Land at Climping, West Sussex

Transport Statement

i-Transport Ref: TW/BB/ITB16079-002D

Date: 22 March 2022

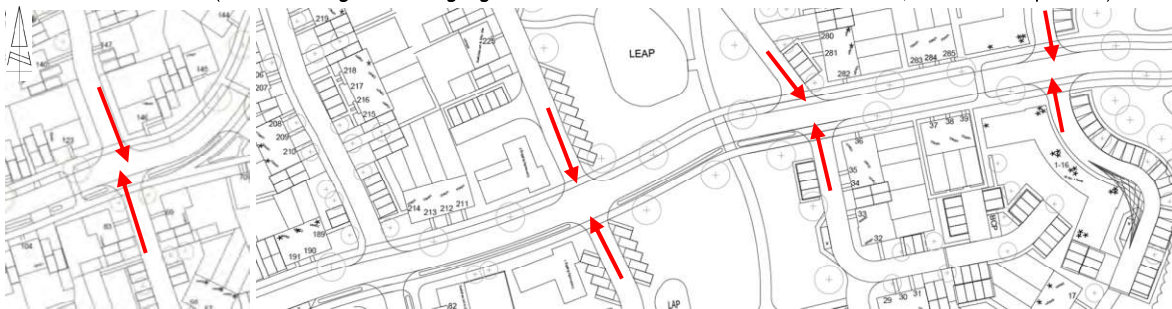
DESIGN ORGANISATION RESPONSE provided by i-Transport on the 15 th March 2022 following formal issue of this Stage 1 Road Safety Audit on the 14 th March 2022	
Agreed – a covenant will be placed on the affected properties requiring that any planting must be maintained below 600m to ensure the visibility envelopes can be achieved.	
AUDITOR'S VIEW OF DESIGN ORGANISATION RESPONSE dated 15 th March 2022	
Confirmation that visibility will be maintained clear of obstructions, addresses the road safety concern at this stage.	
A.2	GENERAL
	No Road Safety Concerns in GENERAL have been raised at this stage
A.3	JUNCTIONS
A.3.1	PROBLEM
Location:	Scheme
Summary:	Visibility extends across land outside the proposed highway
Acc Type:	Vehicle side impact collisions
The proposals associated with this Stage 1 Road Safety Audit, includes general carriageways with footways as well as shared surface areas that are to be provided within a residential development of 300 dwellings that each accommodate off-street parking, be it within driveways or parking courts. The scheme drawings provided with the Audit Brief, illustrate that 25 metre visibility splays are achievable where carriageways meet in accordance with the stopping sight distance of approaching vehicles travelling at 20mph. The presence of speed control bends and traffic calming measures in the form of raised tables and shared surface areas should ensure vehicular speeds are maintained low and that the achievable visibility is adequate. However, the visibility splays illustrated at many of the driveways and entrances to the parking courts, to include in proximity to the local shops and nursery, pass over land that is assumed to be outside the public highway. Should vegetation be planted and permitted to grow within the areas, visibility to and from approaching vehicles could be limited which may lead to a vehicle attempting to exit a priority access when it is not safe to do so, into the path of an oncoming vehicle and lead to side impact collisions.

RECOMMENDATION:	
It is recommended that a sufficient level of visibility is achievable at all times	
Location Plan: (NB: The image below highlights three locations where this item is relevant, more are be present)

DESIGN ORGANISATION RESPONSE provided by i-Transport on the 15 th March 2022 following formal issue of this Stage 1 Road Safety Audit on the 14 th March 2022	
Agreed – A covenant will be placed on the affected properties requiring that any planting must be maintained to 600mm or below to ensure that visibility splays can be achieved.	
AUDITOR'S VIEW OF DESIGN ORGANISATION RESPONSE dated 15 th March 2022	
Confirmation that visibility will be maintained clear of obstructions, addresses the road safety concern at this stage.	
A.3.2	PROBLEM
Location:	Scheme
Summary:	Priority may not be clear to drivers approaching junctions
Acc Type:	Vehicle side impact collisions
The proposals associated with this Stage 1 Road Safety Audit, includes general carriageways with footways as well as shared surface areas with a number of crossroad junctions generated. Vehicular speeds are expected to be low and priorities should be clear where surface treatments change, however, no such details have been provided at this stage and drivers will be able to see through the junction. There are concerns that traffic may approach the primary roads at inappropriate speeds and overshoot into the path of oncoming traffic or fail to give-way leading to side impact collisions

RECOMMENDATION:	
It is recommended that the point at which traffic must give-way is clear	
Location Plan: (NB: The image below highlights two locations where this item is relevant, more are be present) 	
DESIGN ORGANISATION RESPONSE provided by i-Transport on the 15 th March 2022 following formal issue of this Stage 1 Road Safety Audit on the 14 th March 2022	
Agreed – Road markings will be provided at priority junctions with the primary roads and at the entrance to / exit from the parking facility associated with the proposed local shops.	
AUDITOR'S VIEW OF DESIGN ORGANISATION RESPONSE dated 15 th March 2022	
Confirmation that road markings will be provided where appropriate, addresses the road safety concern at this stage.

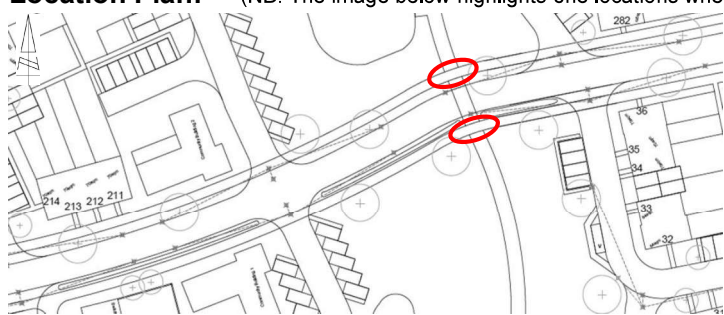
A.4.2	PROBLEM
Location:	Scheme
Summary:	Full height kerbs will be an obstruction to non-motorised users
Acc Type:	Trip / fall and personal injury, vehicle pedestrian collisions
The scheme drawing provided with the Audit Brief, identifies that the proposed development is to consist of general carriageways with footways as well as raised shared surface areas with direct accesses to pathways to properties and footpath / cyclepath links. At this stage no details have been provided to identify the proposed edge treatment around the shared surface areas. Kerbing in excess of 6mm is a trip hazard for pedestrians, those with perambulators, the mobility impaired and cyclists which could lead to falls and personal injury. Further, visually impaired pedestrians could enter a live carriageway into the path of a vehicle unaware leading to a vehicle pedestrian collision	
RECOMMENDATION:	
It is recommended that level access is provided with tactile paving where appropriate along non-motorised user desire lines.

Location Plan: (NB: The image below highlights some locations where this item is relevant, more are present) 	
DESIGN ORGANISATION RESPONSE provided by i-Transport on the 15th March 2022 following formal issue of this Stage 1 Road Safety Audit on the 14th March 2022	
Agreed - Desire lines will be assessed during the detail design of the scheme with dropped kerbs and tactile paving provided where necessary.	
AUDITOR'S VIEW OF DESIGN ORGANISATION RESPONSE dated 15th March 2022	
Confirmation that dropped kerbs and tactile paving will be provided, addresses the road safety concern raised at this stage.

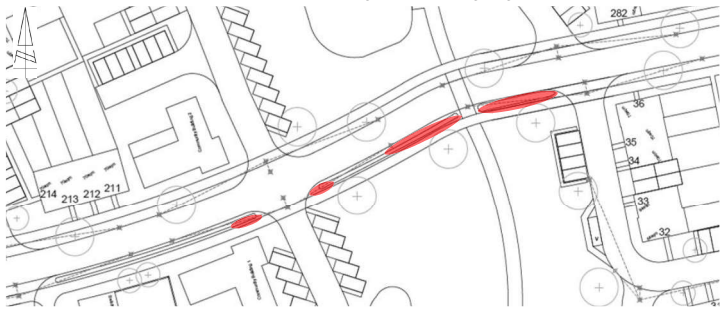
A.4.3	PROBLEM
Location:	Southern side of primary spine road
Summary:	No warning is provided to highlight the change in characteristics of the footways
Acc Type:	Vehicle pedestrian collisions
The proposals include the provision of numerous footways as well as shared surface areas and footpaths / cyclepaths through the open space within the application site. The Audit Team have concerns that pedestrians travelling from a footway will step onto a shared area without warning that cyclists or vehicular traffic could be present. A pedestrian not becoming aware that they are entering a shared area where cyclists or motorists could be present, may step into their path leading to a vehicle / cyclist collision with a pedestrian.	
RECOMMENDATION:	
It is recommended that corduroy / hazard warning tactile paving is provided where the characteristics of the surface change	
Location Plan: (NB: The image below highlights one locations where this item is relevant, more are present)

DESIGN ORGANISATION RESPONSE provided by i-Transport on the 15th March 2022 following formal issue of this Stage 1 Road Safety Audit on the 14th March 2022	
Agreed – Corduroy paving will be provided where necessary, this will be dealt with at the detailed design stage.	
AUDITOR'S VIEW OF DESIGN ORGANISATION RESPONSE dated 15th March 2022	
Confirmation that tactile paving will be provided where appropriate, addresses the road safety concern raised at this stage.	
A.4.4	PROBLEM
Location:	Southern side of primary spine road
Summary:	Hedges could grow to limit visibility to and from a non-motorised user
Acc Type:	Vehicle pedestrian collisions
The proposals include the provision of numerous footpaths / cyclepaths through the proposed development area as well as footways besides the proposed on-site carriageways. The site layout plan provided with the Audit Brief, illustrates what is believed to be hedges to the south of the primary spine road and either side of where the proposed footpaths meet the carriageway. No landscaping details have been provided at this stage. Should the planting be permitted to grow higher than 600mm there is a risk that insufficient intervisibility will be available. Recent updates

to the Highway Code have introduced pedestrian and cyclist priorities over vehicular traffic and therefore drivers are required to stop and to allow non-motorised users to cross side roads, however, limited visibility could result to the users not becoming aware of one another at a safe distance leading to vehicle non-motorised user collisions	
RECOMMENDATION:	
It is recommended that no foliage is planted within pedestrian visibility slays to ensure clear visibility is maintained at all times	
Location Plan: (NB: The image below highlights two locations where this item is relevant, more are present) 	
DESIGN ORGANISATION RESPONSE provided by i-Transport on the 15 th March 2022 following formal issue of this Stage 1 Road Safety Audit on the 14 th March 2022	
Agreed – this will be dealt with at the detailed design stage.	
AUDITOR'S VIEW OF DESIGN ORGANISATION RESPONSE dated 15 th March 2022	
Confirmation that this road safety concern will be further considered during the detail design of the scheme, addresses the road safety concern raised at this stage.

Item Location Plan

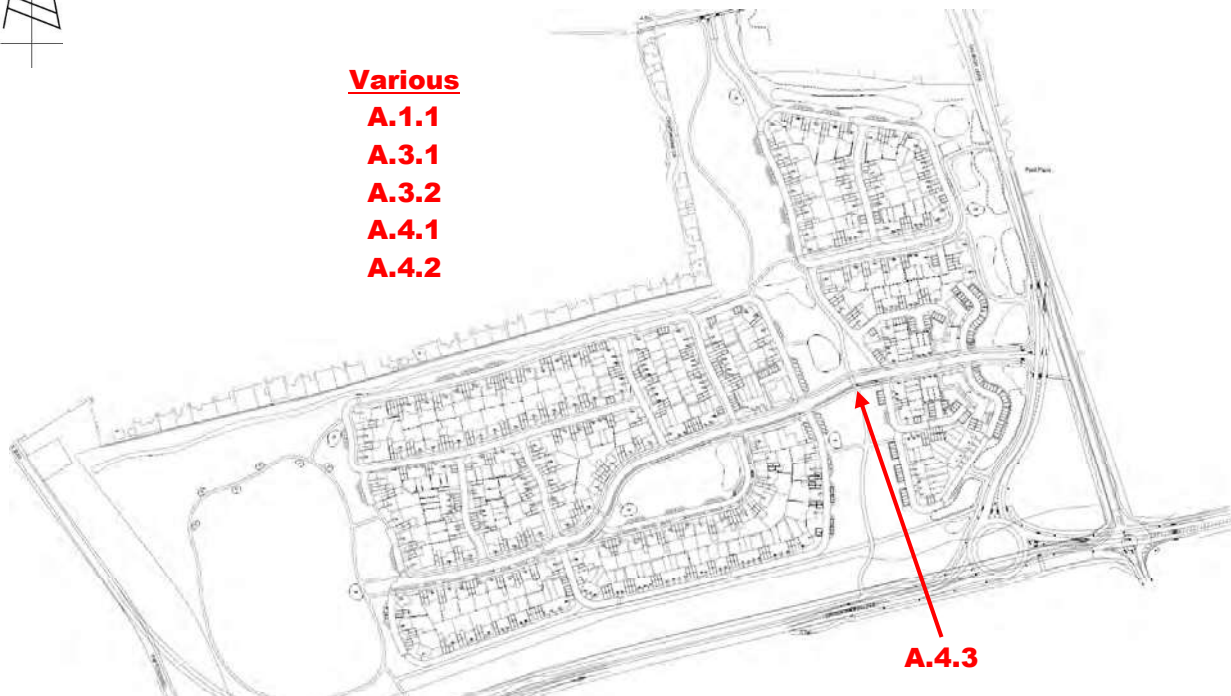
- A.1.1 – Forward visibility at some locations passes over land that is assumed to be outside the public highway. The Audit response confirmed that covenants will be placed on any affected properties, requiring that any planting be maintained below 600mm to ensure the visibility envelopes are achieved. This addressed the concern.

- A.3.1 – Visibility splays at some entrances to parking courts and driveways pass over land that is assumed to be outside the public highway. The Audit response confirmed that covenants will be placed on any affected properties, requiring that any planting be maintained below 600mm to ensure the visibility splays are achieved. This addressed the concern.
